CERTIFIED SURVEY MAP (CSM) APPLICATION & REVISED LANDSCAPE PLAN

11/13/23 Plan Commission Meeting

Virtus Development LLC / District One LLC

Village Staff Report & Recommendation

SHEET NO:
C1.02

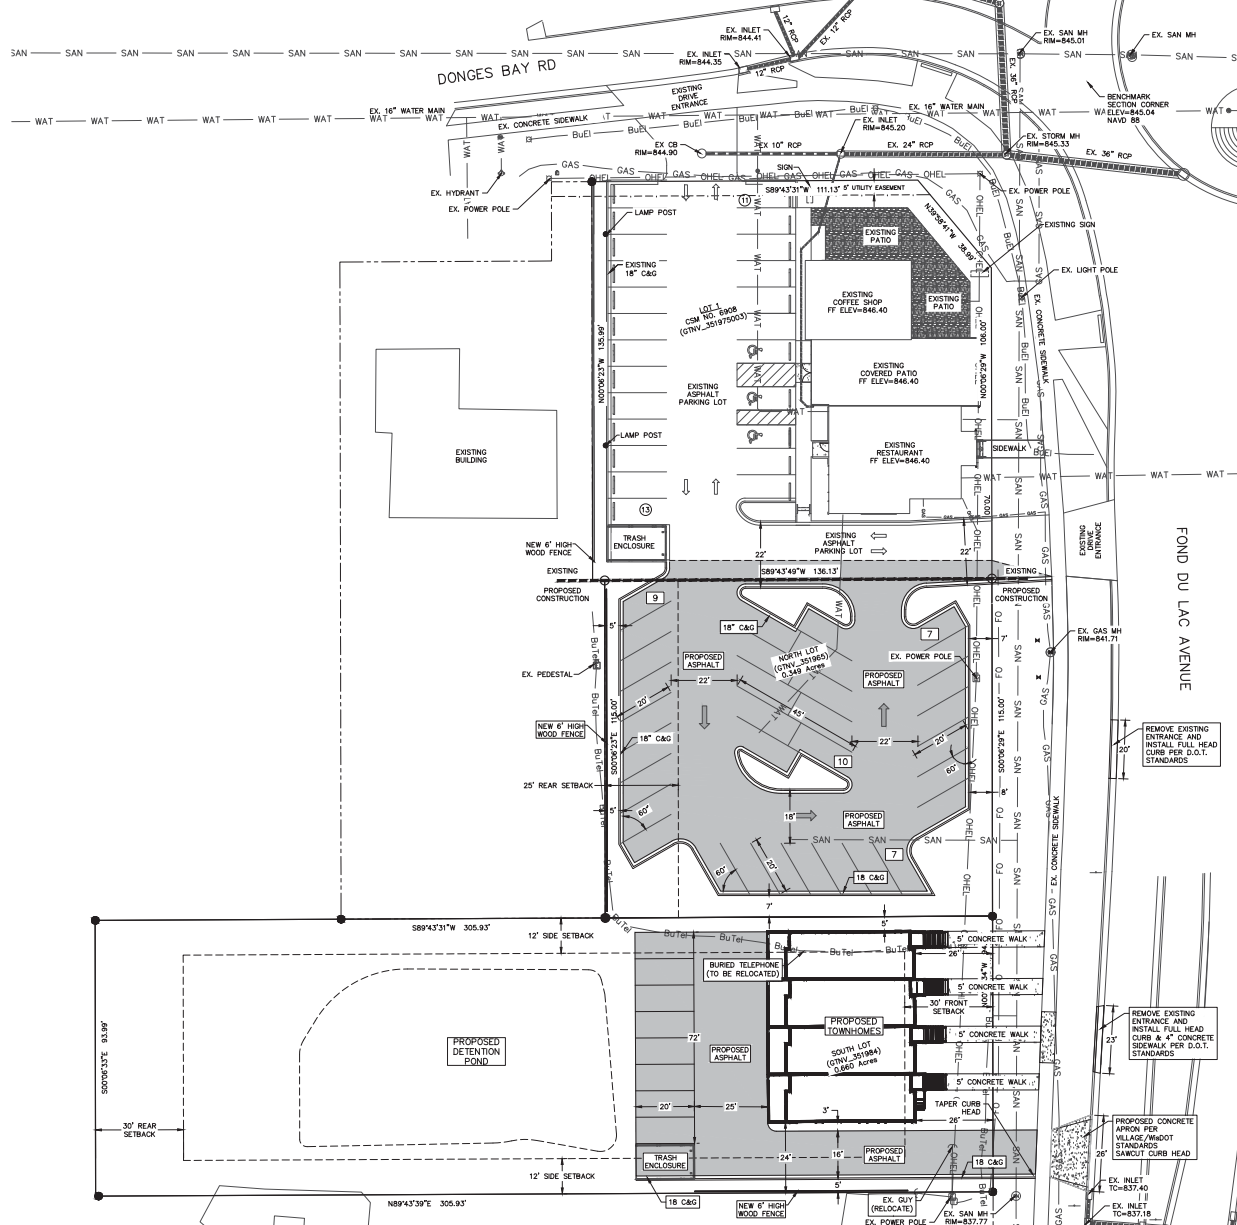
There are no details, specifications, or renderings for the "decorative fence" that is required *"...along the entire length of the paved driveway and parking stall area"* abutting the south property line. The "Planting Plan" or landscape plan refers to a "proposed fence" where other site plan sheets including C1.02 indicate a "New 6' High Wood Fence". The requirement for a "decorative fence" is part of the PDD conditions & restrictions resolution and adopted as a condition in the August 14 Plan Commission approval of the site plan set. It was Staff's intent that a decorative privacy fence and a landscaping buffer along the entire south property line (vs. a basic dog-eared wood picket fence like the one installed along the commercial parking lot) would provide a more appealing visual screen for the residents. I do not consider a basic 6' high, dog-eared wood pickets mounted on steel poles to be the least bit decorative.

With respect to the same south property line fence, neither the Planting Plan nor the site plan sheets clearly show this new fence along the entire length of the driveway. The Planting Plan calls out a solid black line that appears to be one and the same as the property line. So, if that is the case and the fence is proposed along the entire length of the property line, then the requirement has been met. If not, the plan needs to be revised to clearly show a decorative privacy fence along at least the length of the driveway from the property line to the west end of the parking stalls as required.

Also, with respect to the same south property line, the Plan Commission approval and PDD conditions require a "landscape screen/buffer" in addition to the privacy fence. The Planting Plan shows three small 4' x 6' wide planting areas with daylilies in each on the north side of the privacy fence. As indicated above, Staff's intent is that the landscaping buffer be located on the south side and along the entire length of the fence to provide a visual buffer for the residential property owner to the south.

- a. Planting Plan dated November 3, 2023
2. As required under Condition #3 of the August 14, 2023 Plan Commission Site Plan approval, a decorative privacy fence and landscape screen/buffer shall be installed along the entire length of the paved driveway and parking stall area abutting the south property line. The decorative privacy fence shall be a minimum of 6 feet height and not be a simple board-on-board wood picket fence. The landscaping shall also be installed along the south side of the fence.
